## ORIGINATION FORM

Proposed Revisions to a Standard Plans Index  
(Please provide all information — Incomplete forms will be returned)

Index Number: 522-002  
Sheet Number (s): 1 and 4 of 7  
Index Title: Detectable Warnings and Sidewalk Curb Ramps

==== CURB RAMP NOMENCLATURE ====

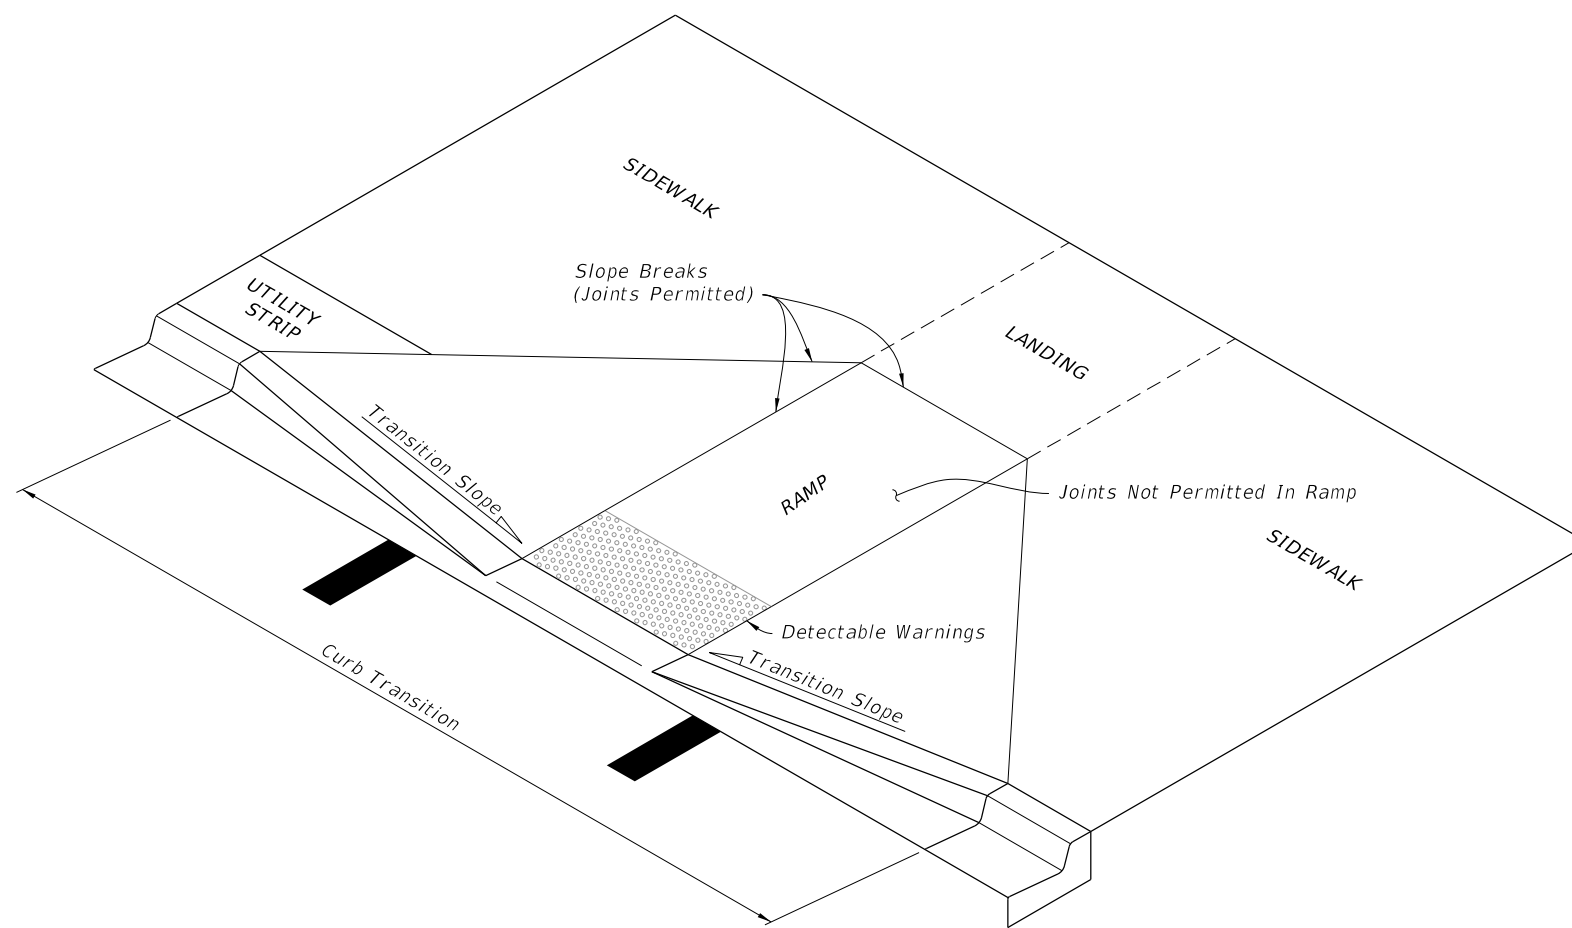
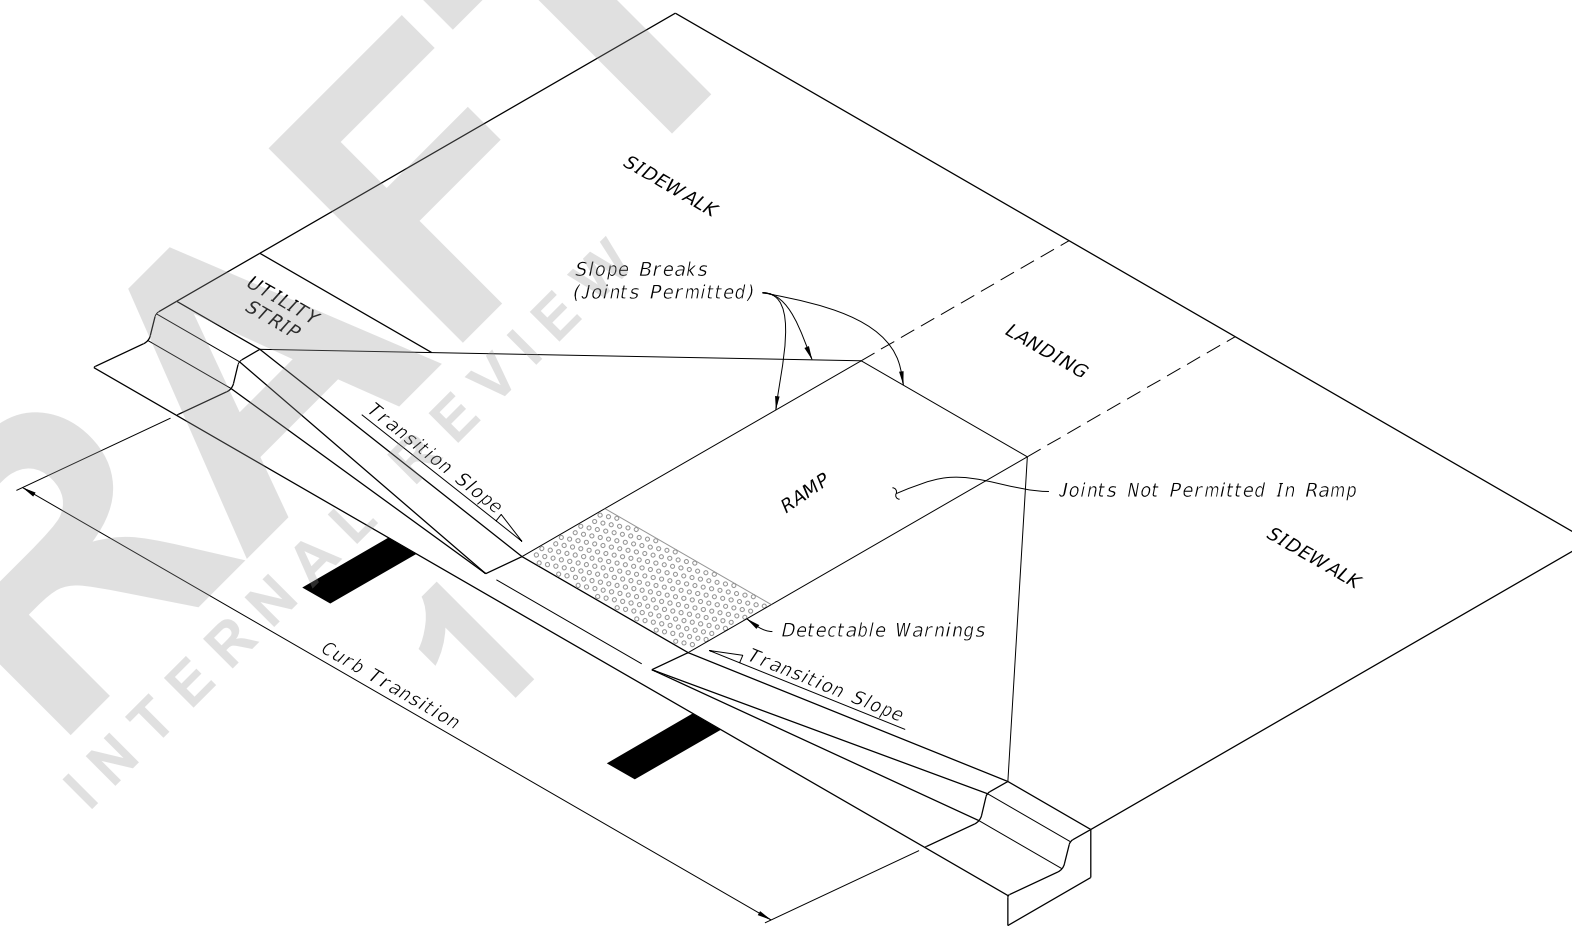
- Sheet 1: Added Note 2.C.

**ADDED NOTE 2.C:**  
Width of Curb Ramp is 4'-0" minimum. Match sidewalk or Shared Use Path width as shown in the Plans.

- A. Refer to Index 522-001 for concrete thickness and sidewalk details.
- B. Remove any existing curb, curb and gutter, or sidewalk to the nearest joint beyond the curb transition or to the extent that no remaining section is less than 5 feet long.
- C. Width of Curb Ramp is 4'-0" minimum. Match sidewalk or Shared Use Path width as shown in the Plans.

CR-D

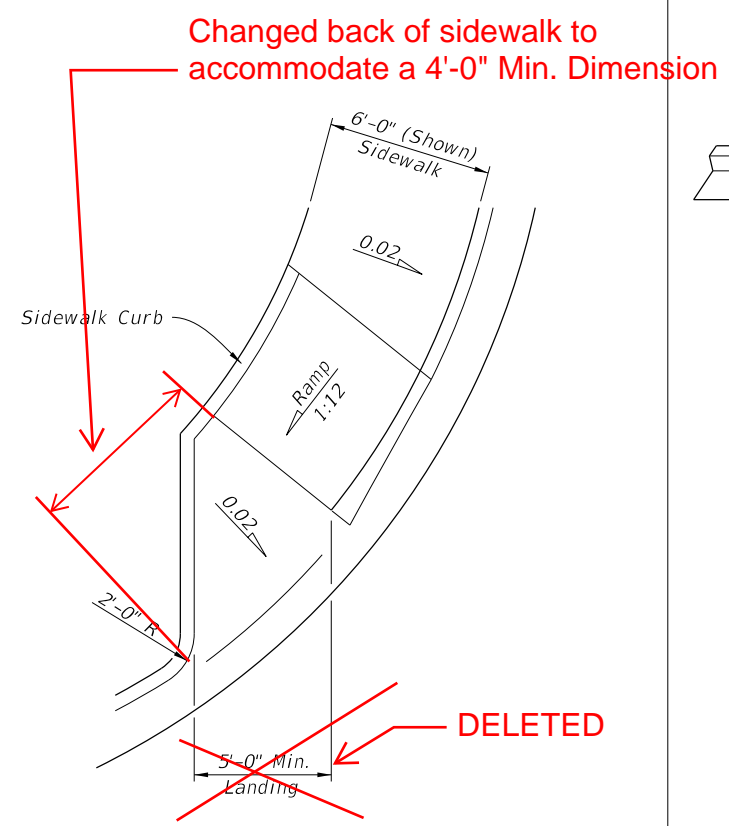
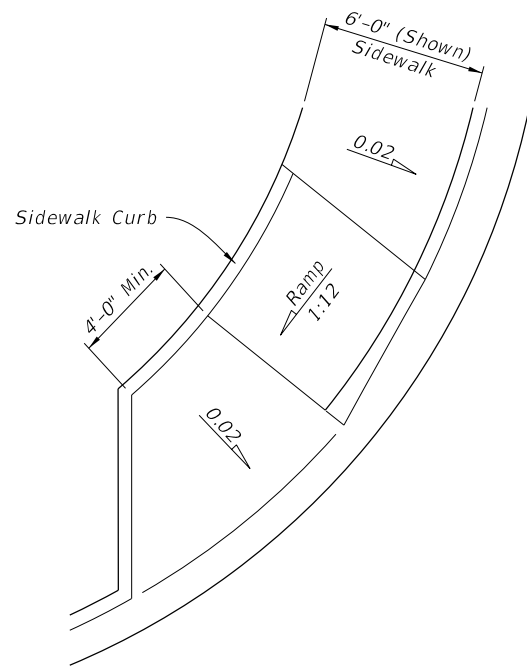
- Sheet 4: Changed back of sidewalk in CR-D detail to accommodate 4'-0" minimum dimension.

CR-D is essentially half of a CR-C. The CR-C ramp currently shows the 4'-0" minimum dimension at the back of sidewalk to provide a large-enough level landing footprint for wheelchair maneuverability. The CR-D, as currently depicted in the Standard Plans, does not provide an optimal configuration for users of mobility devices. See next page for additional information.

For CR-D, provide 5'-0" standard (4'-0" minimum) dimension at back of sidewalk for the level landing at the bottom of the curb ramp (see figure). This provides the necessary plan area footprint for the level landing to allow for wheelchair maneuverability and change of direction. Otherwise, the footrest of a wheel chair would contact the curb face while the rear wheels are still on the ramp's sloped surface -- potentially resulting in an unstable/tip-over condition.

Ideally, the resulting curb return would remain parallel to and in alignment with the direction of the crossing, and that is why 5' standard is proposed with a 4' minimum.
